CITY OF BOULDER
PLANNING BOARD MEETING AGENDA
DATE: August 18, 2016
TIME: 6 p.m.
PLACE: 1777 Broadway, Council Chambers

AGENDA TITLE: CONCEPT PLAN & REVIEW - Redevelopment of the existing seven-acre apartment site located at 1550 Eisenhower Drive with a new three-story apartment complex Eastpointe Apartment Homes, consisting of 236 proposed units in five buildings with below grade parking and on-site recreational amenities under case review no. LUR2016-00043.

SUMMARY:	CONCEPT PLAN & REVIEW – Proposal for five new three-story apartment buildings, a fitness building and associated site amenities with below grade parking. A total of 236 apartment units are proposed where 140 units exist today.
Project Name:	Eastpointe Apartment Homes
Location:	1550 Eisenhower Drive
Size of Tract:	Seven acres
Zoning:	Residential – High 4 (RH-4)
Comprehensive Plan:	High Density Residential
Key Issues:	Staff has identified three key issues for consideration: • Consistency with the BVCP (per Concept Plan Review Criteria); • Concept Plan responsiveness to existing context

Figure 5: Tree Inventory

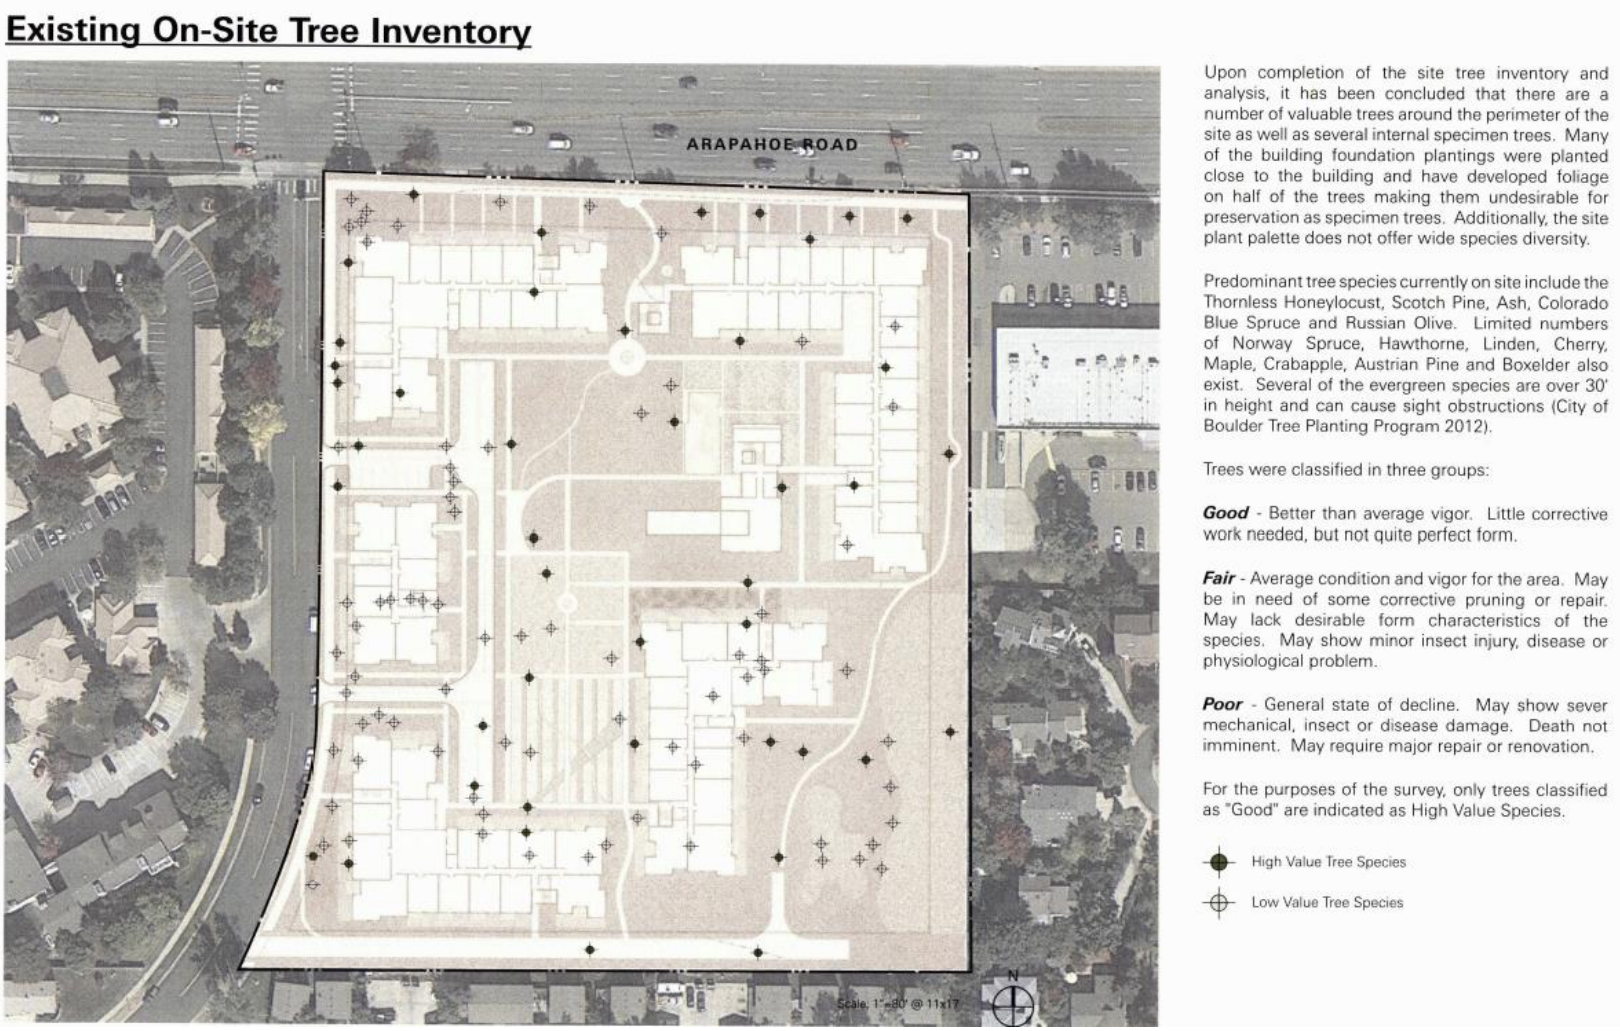
Existing Site Conditions. As shown in the Tree Inventory (Figure 5) there are a number of existing, mature trees on the site, and an open lawn area in the middle. The applicant provided a tree inventory which concluded that there are "a number of valuable trees around the perimeter of the site as well as several internal specimen trees." The inventory also concluded that "many of the building foundation plantings were planted close to the building and have developed foliage on half of the trees making them undesirable for preservation as specimen trees

Figures 8a (left): Existing Site and Figure 8b (right) Proposed Concept Plan

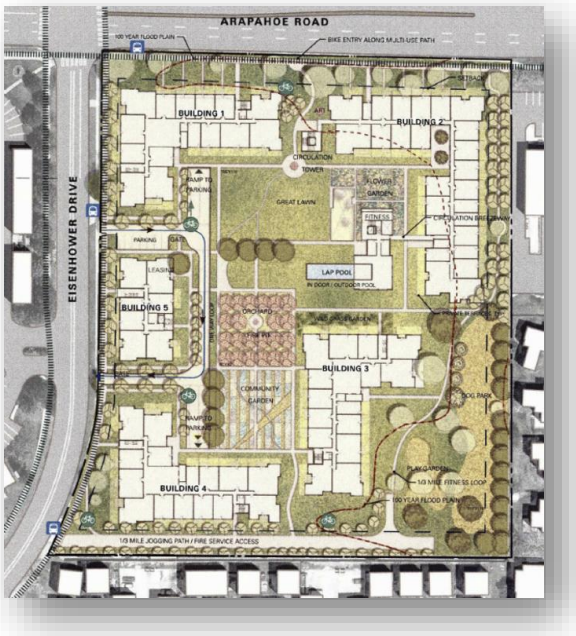
As can be seen in a "thumbnail" the comparison of the existing site and the proposed Concept Plan in **Figures 8a and 8b**, the applicant is improving the amount of open space on the site, both by agglomerating the open space to a more meaningful central area and by moving the parking below grade; and further, by supplementing open space on roof decks.

Figure 9: Urban Design Suggestions to Applicant regarding Concept Plan

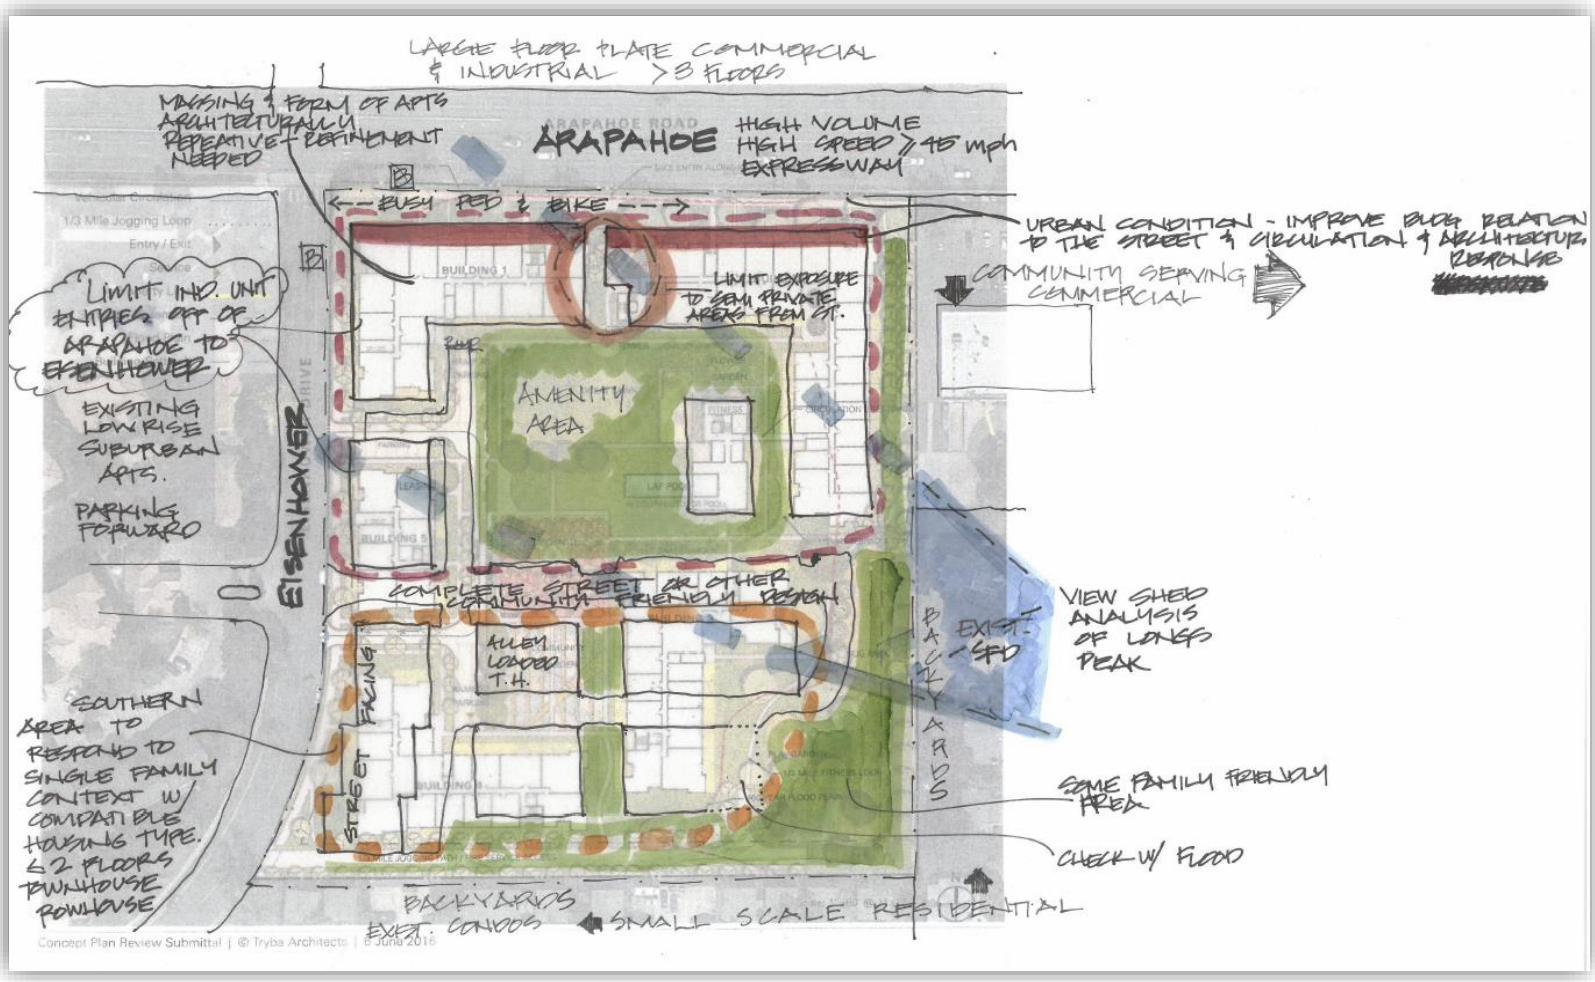
Recognizing the high density land use and zoning on the site and the typology of Arapahoe Avenue, the northern portion of the site can accommodate bigger buildings and a greater degree of intensity however, the proposed site plan should consider the existing surrounding residential uses that are smaller in scale and stature, particularly the single family detached homes to the south. The Site Plan should consider the following to better address the context and surroundings, and as shown in the graphic on the following page in **Figure 9**:

- Break up the superblock by creating a distinct transition to a less massive building type and units on the south side of the site, with the transition being a complete street as shown in **Figure 9**.

- Improve the building's relationship to the street, and circulation and architectural response as the buildings could create more of an urban edge to the broad right-of-way of Arapahoe Avenue, rather than be setback by approximately 50 feet as shown on the Concept Plan, with private yard space along Arapahoe Avenue.

- Limit individual unit entries off of Arapahoe Avenue, given the high volume arterial, and instead provide for overall building entries off Arapahoe and individual unit entries off of Eisenhower.

Figure 11: Exterior Material Proposal

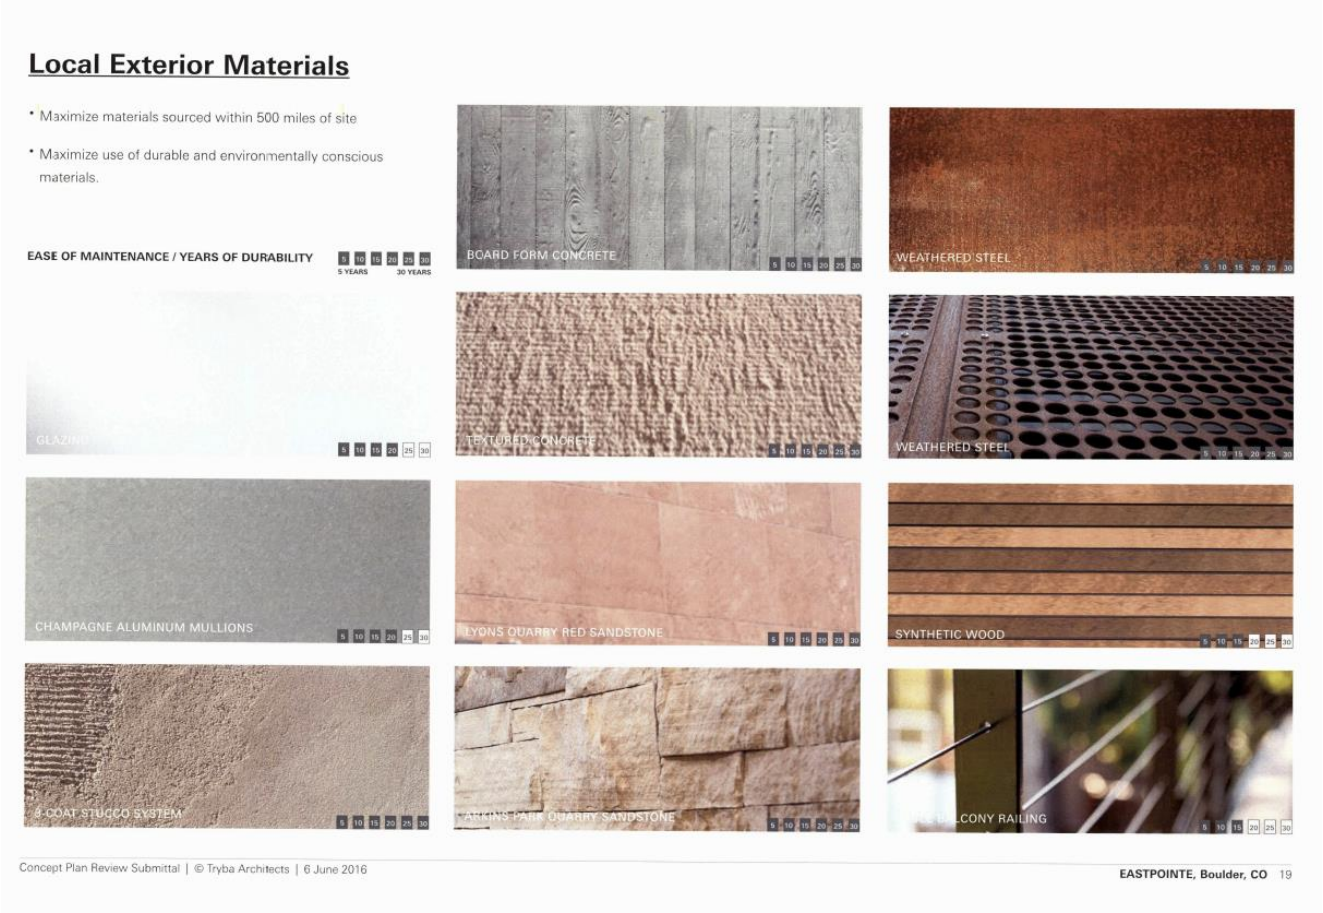
- As discussed with the applicant in a review of the comments, staff and the applicant concurred that some edges or portions of buildings should be converted to two-story massing. Similarly, while the early proposal for exterior materials (shown in **Figure 11**) does appear to be durable and of high-quality, staff recommends reconfiguring the finish materials distinctly on different buildings, such that the buildings don't appear as a duplications of one another.

MOVE BUILDING 4 NORTH 12 FEET

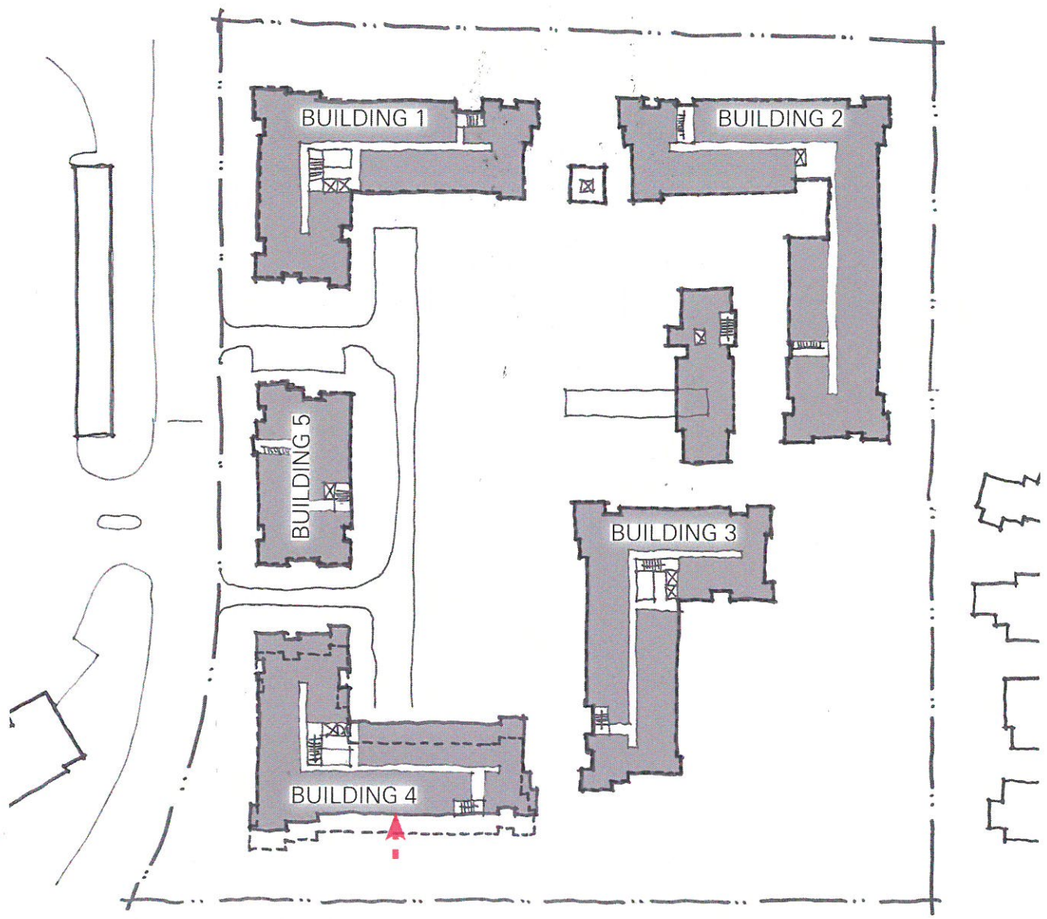
- TO MAINTAIN VIEWS FOR NEIGHBORS

Building Design (Elaine McLaughlin, 303-441-4130)

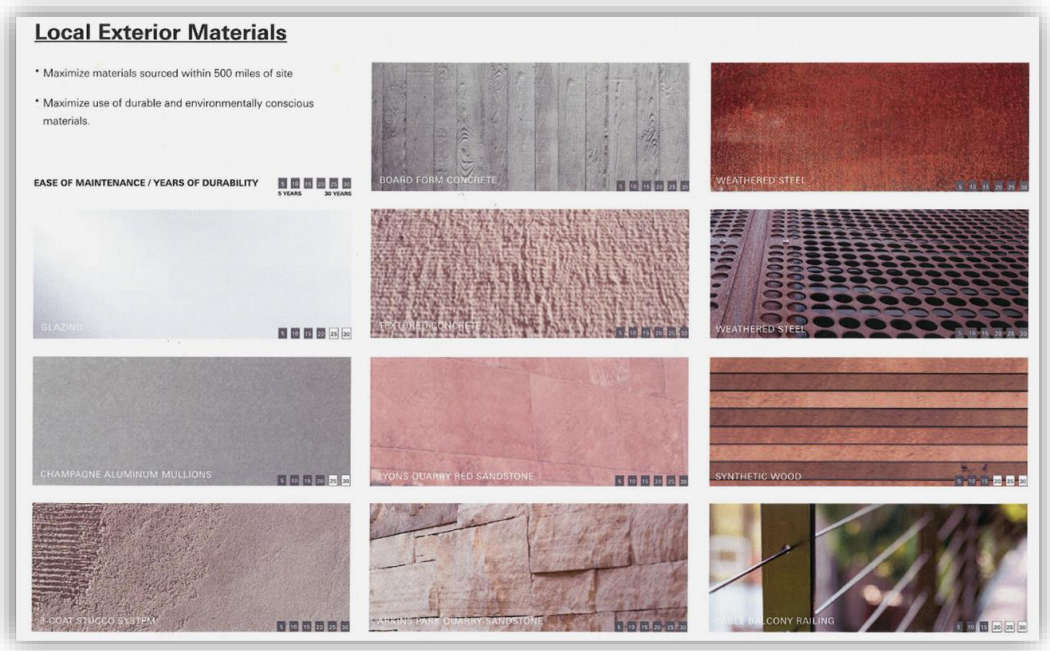
1. While early in the planning process, the applicant provided a strong palette of materials. As project plans progress, the applicant should reference the Site Review criterion (9-2-14(H)(2)(F)(xii) that requires, "*Exteriors of buildings present a sense of permanence through the use of authentic materials such as stone, brick, wood, metal or similar products and building material detailing."* While most of the palette appears to address this criterion, the applicant should consider less use of "stucco" as a primary finish material.

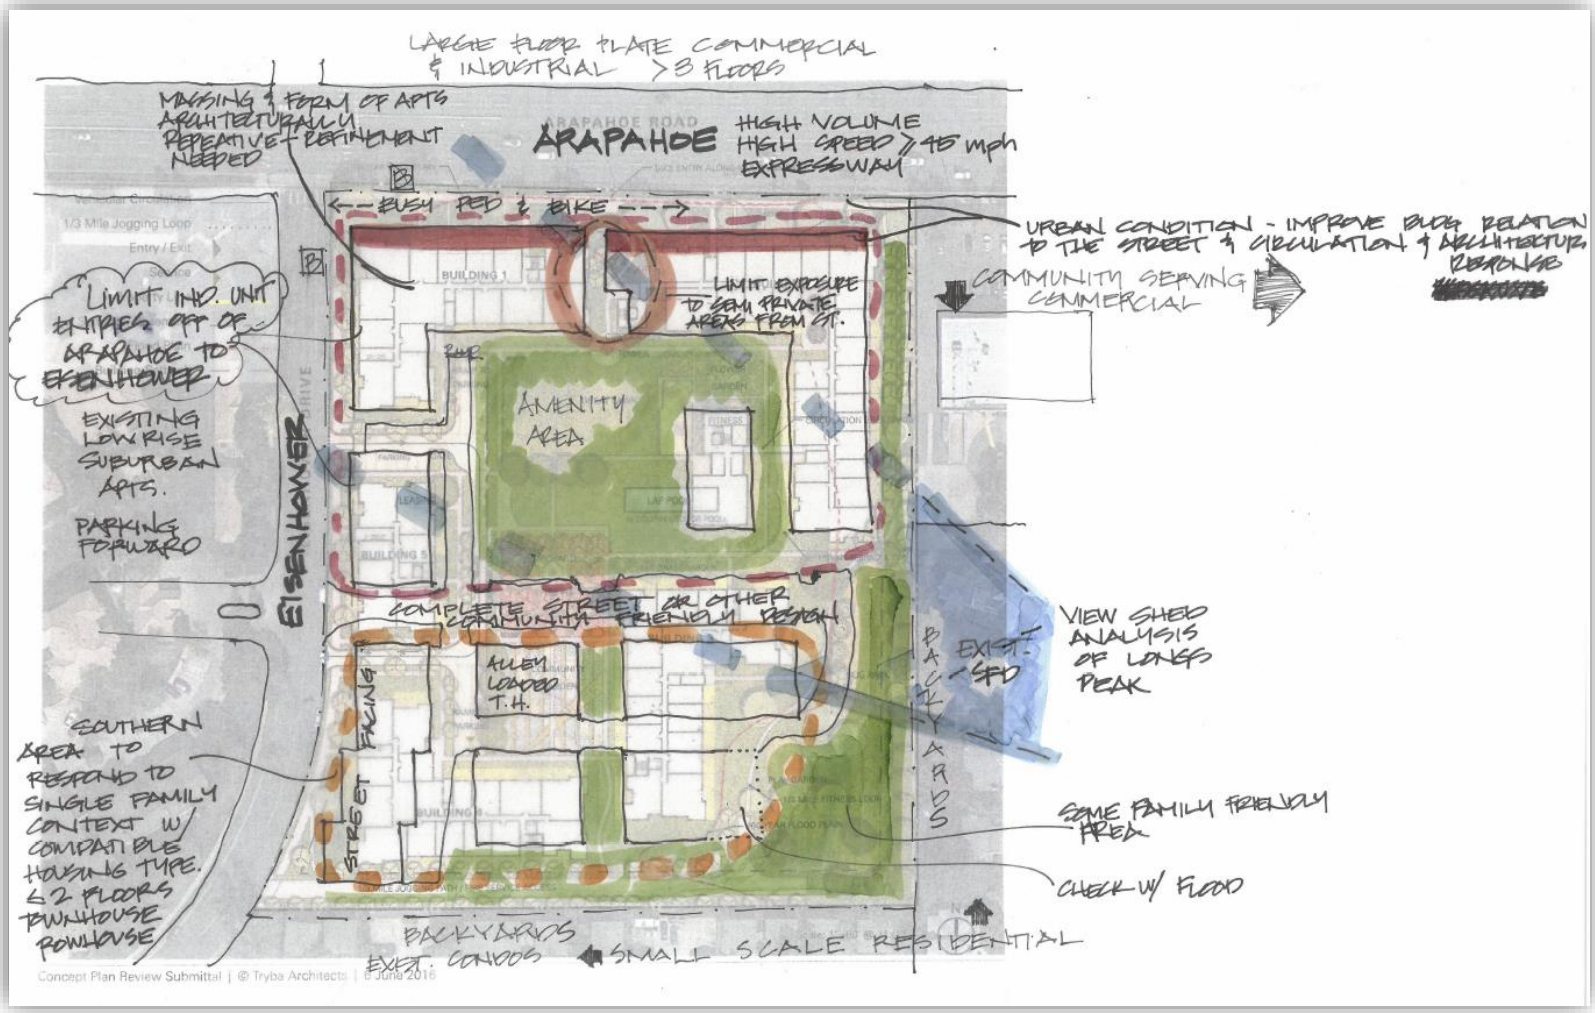
- Setback units from southeast property line and perform a viewshed analysis from adjacent neighborhood to preserve view corridors to the northwest
